PIC12C67X Rev. A Silicon/Data Sheet Errata

The PIC12C67X (Rev. A) parts you have received conform functionally to the Device Data Sheet (**DS30561**), except for the anomalies described below.

Clarifications/Corrections to the Data Sheet:

In the Device Data Sheet (DS30561B), the following clarifications and corrections should be noted.

FIGURE 5-1: GP0 and GP1 Block Diagram

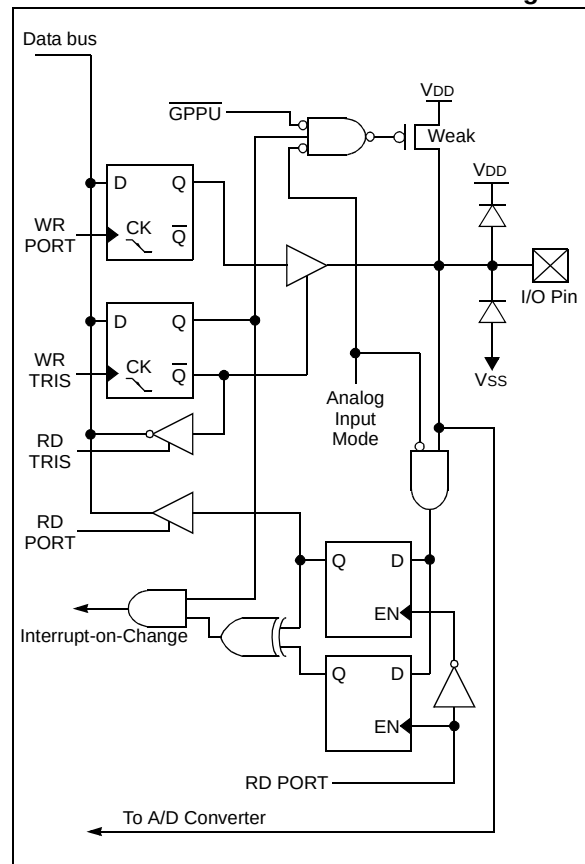
Clarification to the "GPIO", Section 5.1 is provided. New I/O drawings were added.

8-Lead Plastic Micro Leadframe Package (MF) 6x5 mm Body (MLF-S)

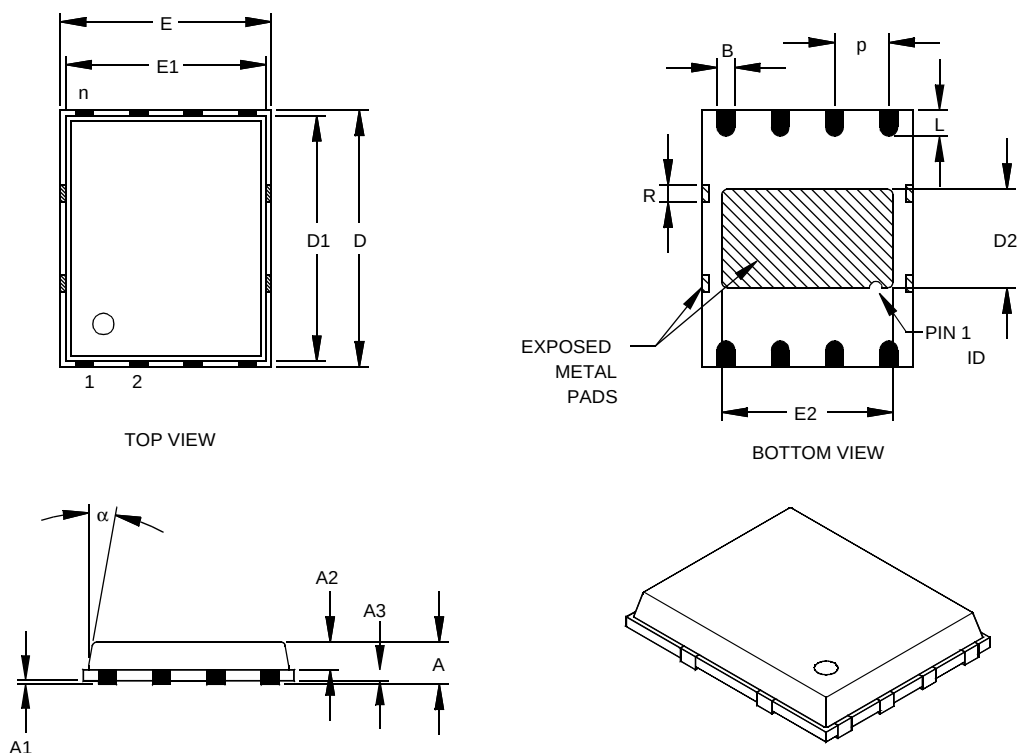
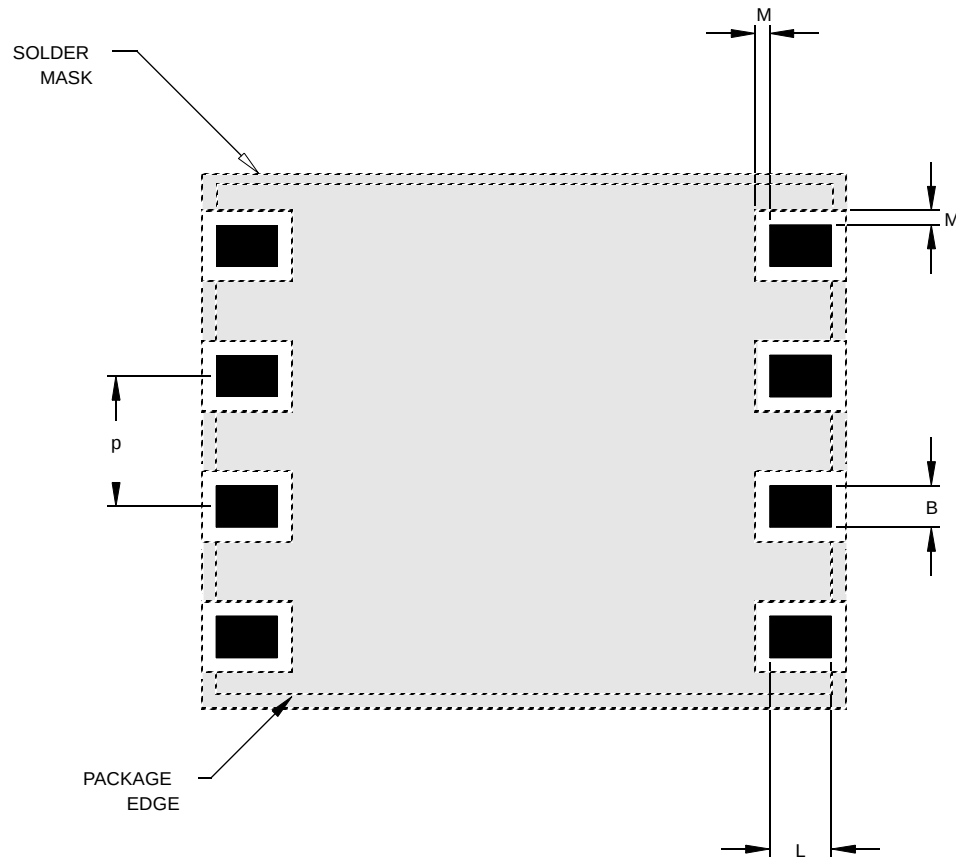
Added 8-Lead Plastic Micro Leadframe Package (MF) and (MLF-S).
